PLAN REVIEW CENTER REPORT

Muscat Property (Abode Salon)

SP #08-18B

Revised Final Site Plan

MUSCAT PROPERTY
SECTION 11, CITY OF NOVI

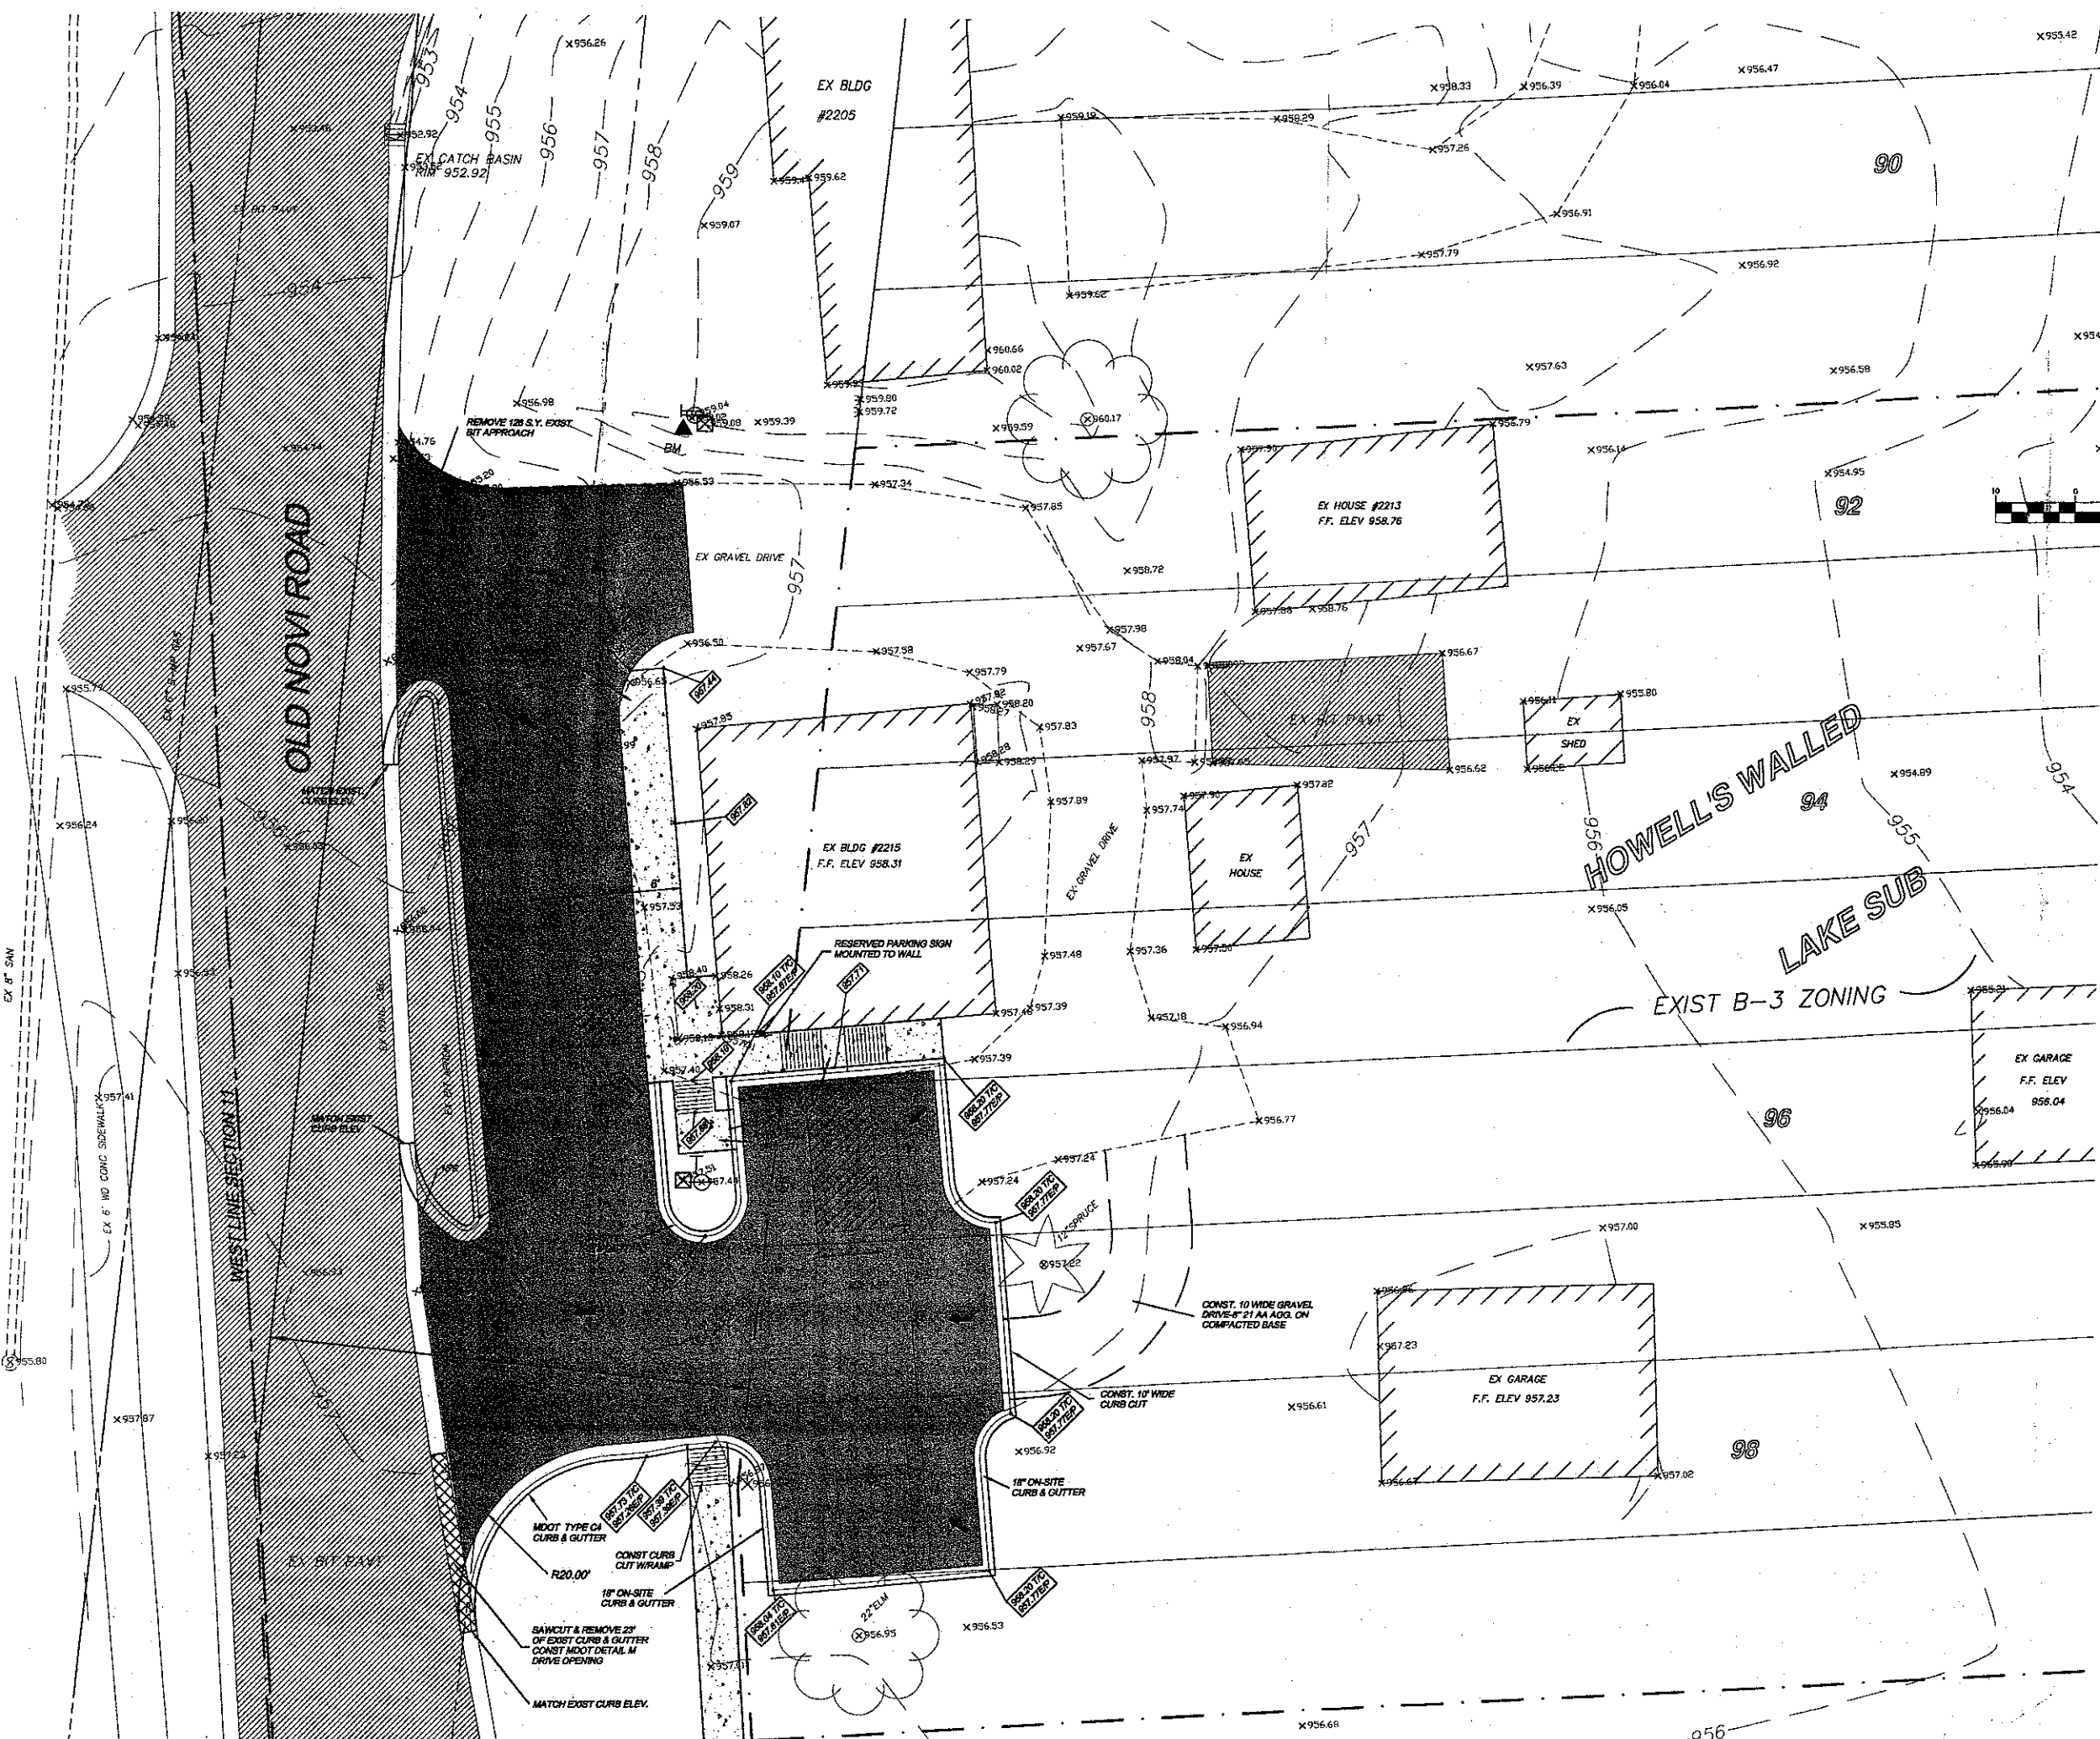
2. The applicant is proposing to locate two parallel parking spaces in front of the building (within the Novi Road right-of-way), and the five remaining spaces are proposed to be located to the south side of the building (within the minimum 20' front yard parking setback). In order to provide this design, the applicant would need to secure a Design and Construction Standards (DCS) Variance from the City Council for parking within the right-of-way, and a Zoning Board of Appeals (ZBA) variance to provide parking within the minimum 20' front yard parking setback, per the standard of Section 2400 of the Zoning Ordinance. If these variances are not approved, the site would need to be redesigned to meet the standards.

3. A Design and Construction Standards (DCS) variance would be required for the lack of sidewalk across the entire frontage of the subject site. If the DCS variance is not secured, the site would have to be redesigned to meet the standards.

4. The 13'-wide access aisle in front of the building must be signed to be one-way (northbound). Please see the Engineering Review for additional details.
